9.1.1 Nos. 33 – 35 (Lots 53 & 350; D/P: 672 & 302361) Mary Street, Highgate – Proposed Additions and Alterations of an Existing Eight Multiple Dwelling Development to a Seven Multiple Dwelling Development and Construction of Two Grouped Dwellings

Ward:	South	Date:	12 June 2015
Precinct:	Precinct 12 – Hyde Park	File Ref:	PR23873; 5.2014.716.1
Attachments:	<u>1</u> – Consultation Map <u>2</u> – Development Application Plans <u>3</u> – Applicant Submission <u>4</u> – Applicant Justification <u>5</u> – Heritage Impact Statement <u>6</u> – Heritage Assessment from Applicant <u>7</u> – Marked up plans showing proposed versus required setbacks <u>8</u> – 3D Perspectives <u>9</u> – Design Advisory Committee Comments		
Tabled Items:	Nil		
Reporting Officer:	A Dyson – Planning Officer (Statutory)		
Responsible Officer:	G Poezyn – Director Planning Services

COUNCIL DECISION ITEM 9.1.1

PROPOSED GROUND FLOOR PLAN SCALE 1:100

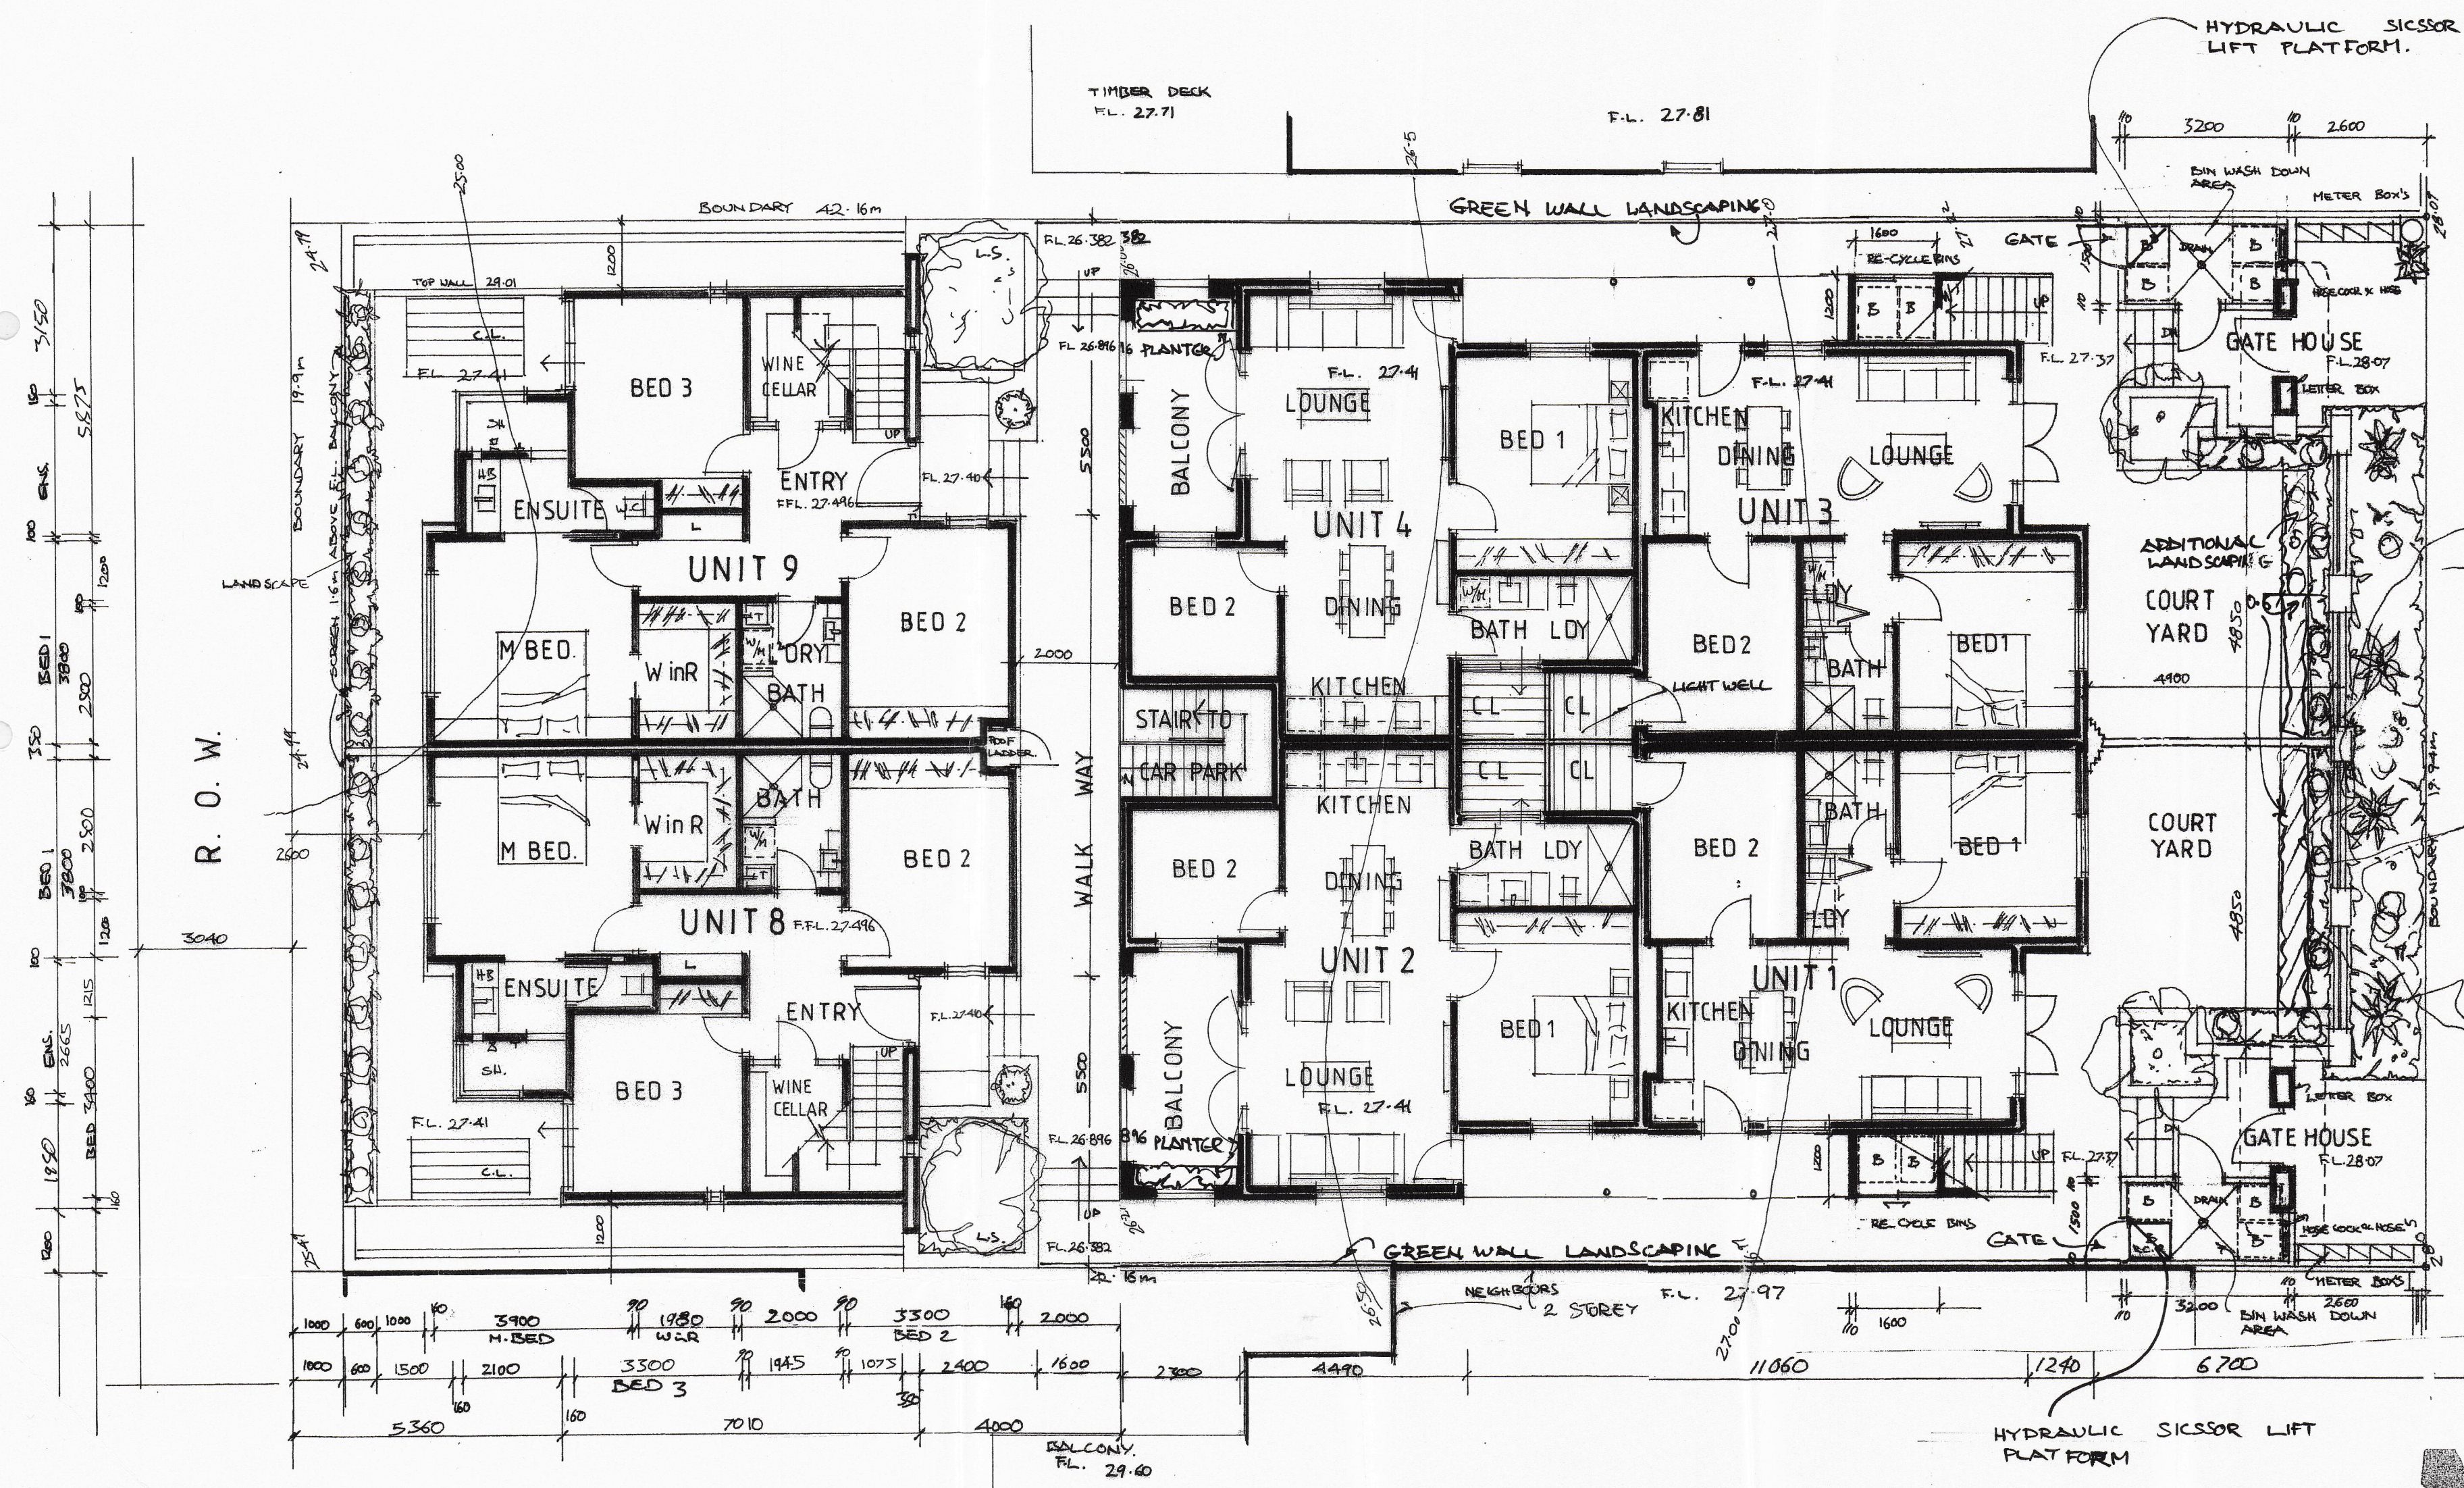
10.1.3 Bin Store

A bin store is required to be provided, of a sufficient size to accommodate the City's maximum bin requirement, as assessed by the City;

8. With regard to Condition 10.2, Council encourages landscaping methods and species selection which do not rely on reticulation;
9. With regard to Condition 10.1.3, the bins access pathway is to be ramped or a mechanical lift to be fitted to allow waste and recycle bins to be taken to Mary Street for collection.

UPPER FLOOR PLAN SCALE 1:100

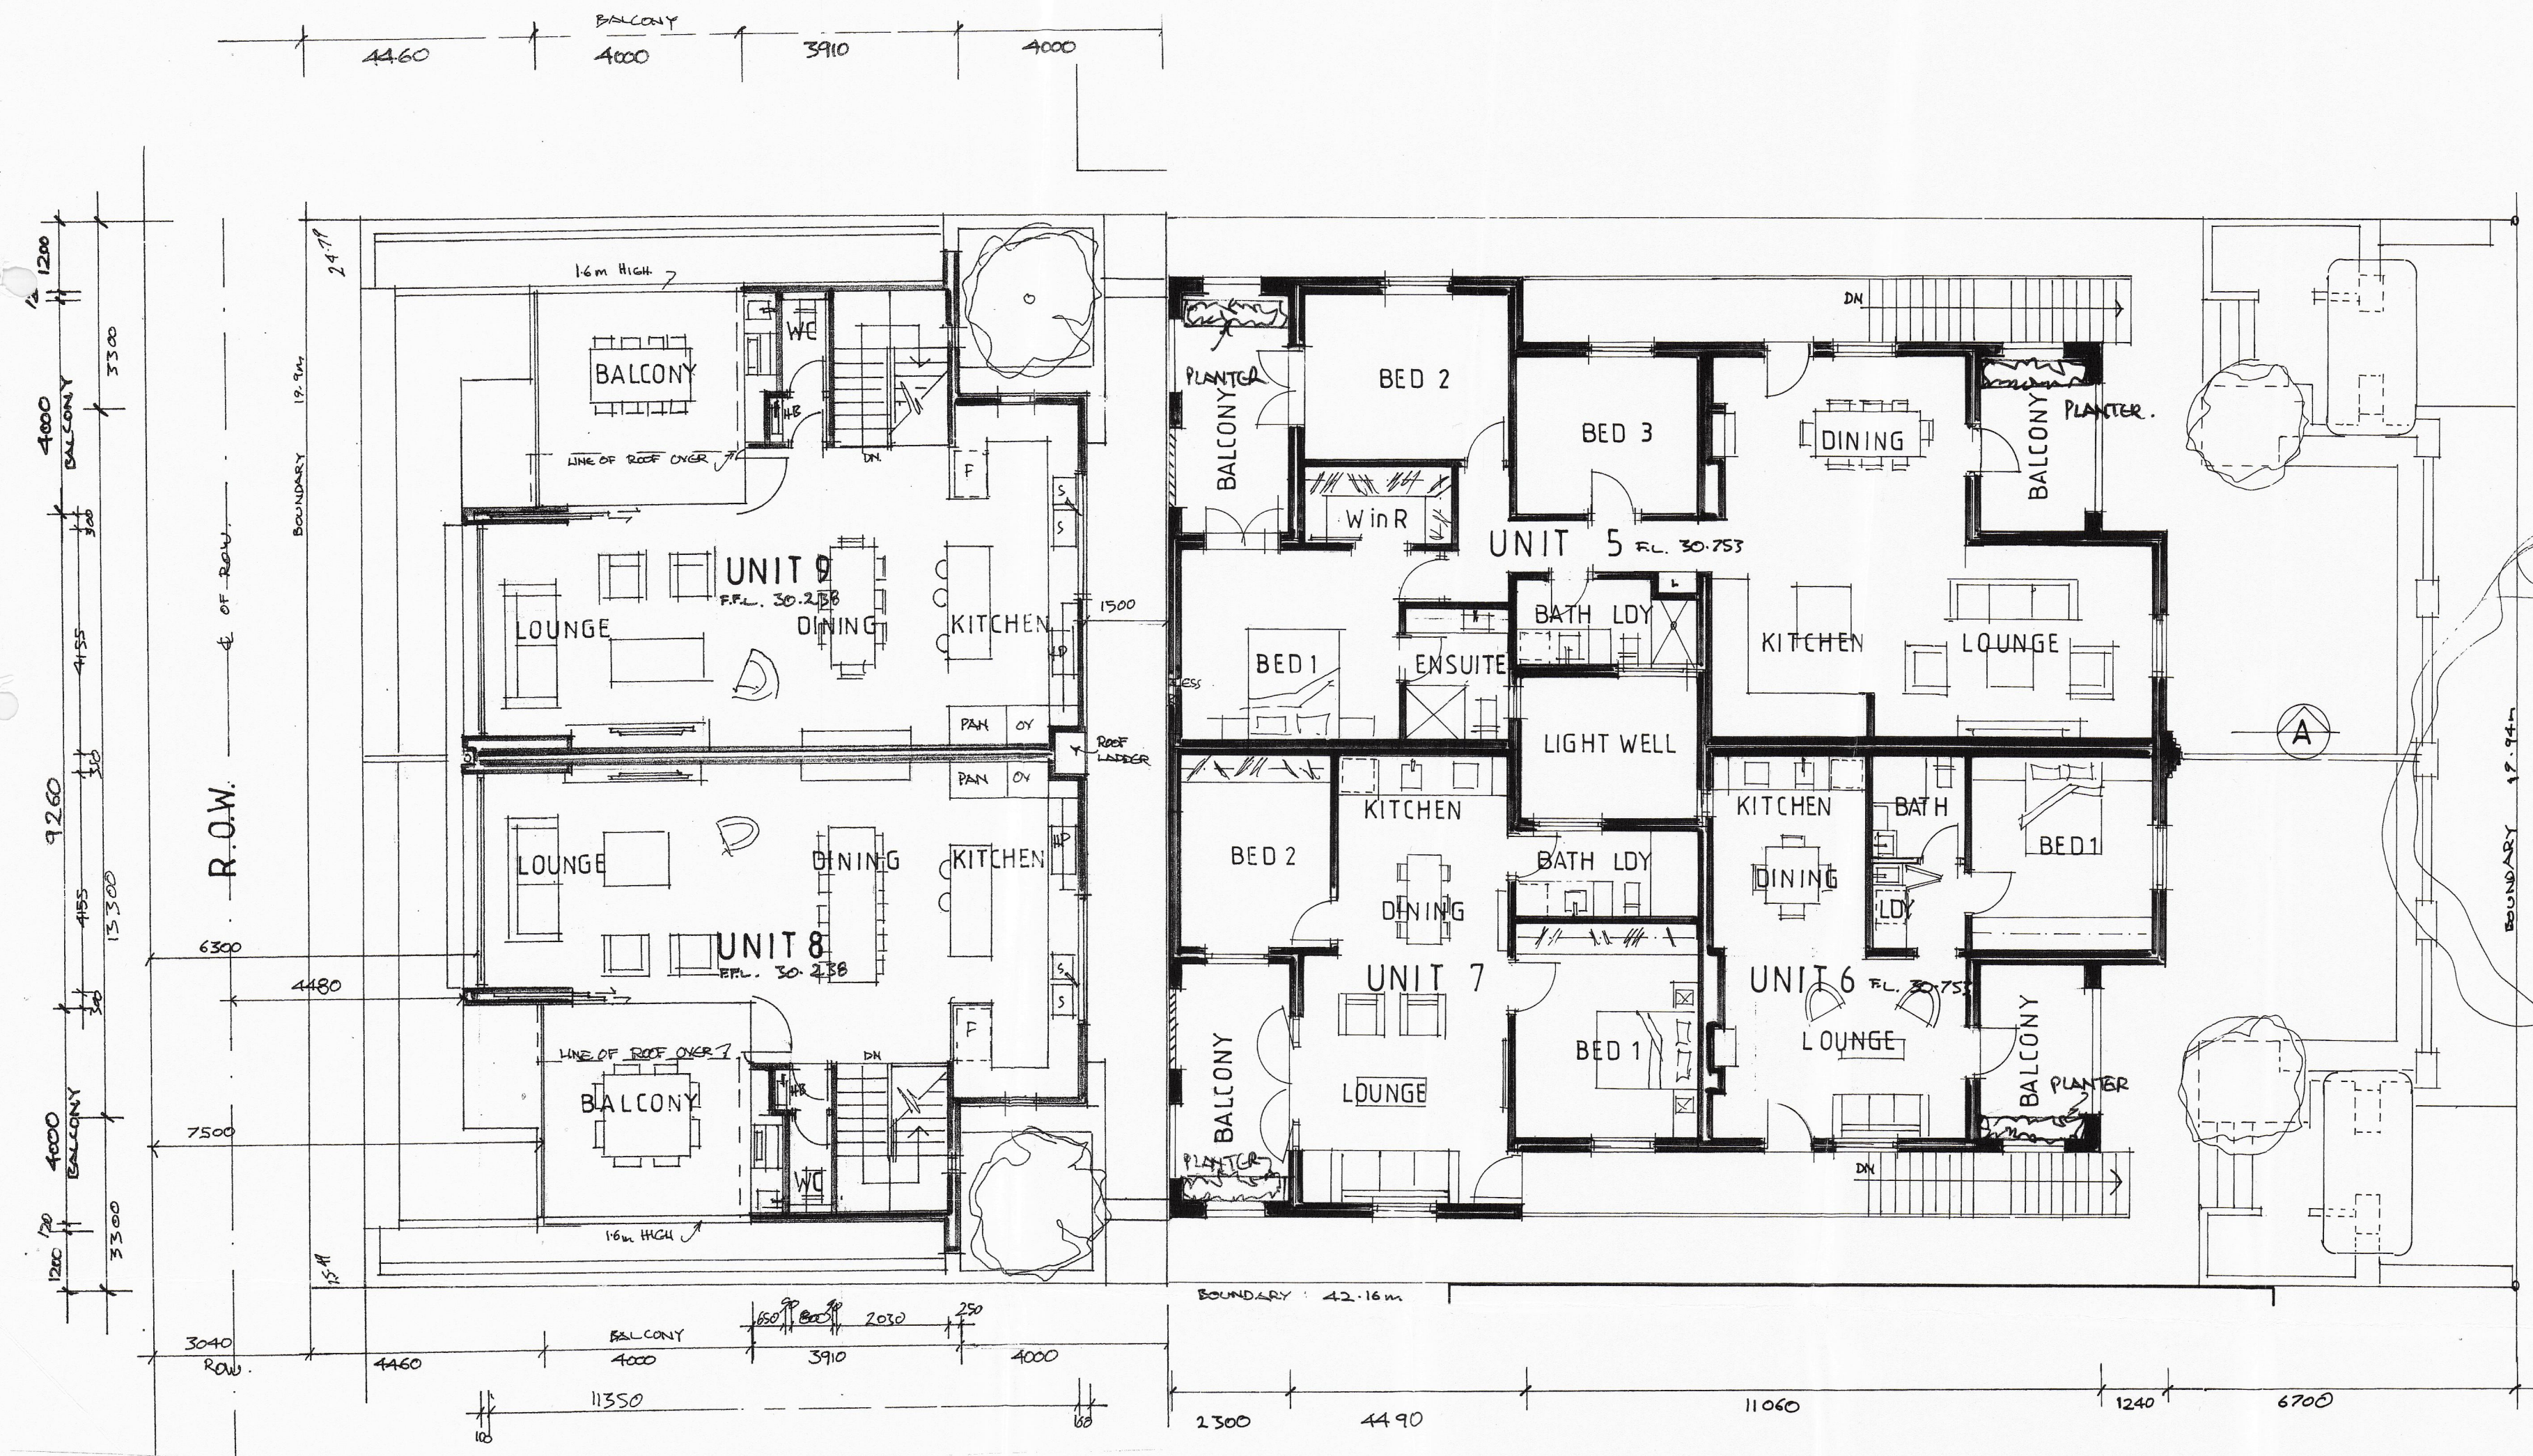
10.1.1 Visual Privacy

The southern façade of the balconies to units 8 & 9 shall comply with the requirements of the 2013 Residential Design Codes in relation to privacy provisions to the satisfaction of the City to prevent overlooking of Nos. 31 (Lot 51) and 37 (Lot 54) Mary Street, Highgate;
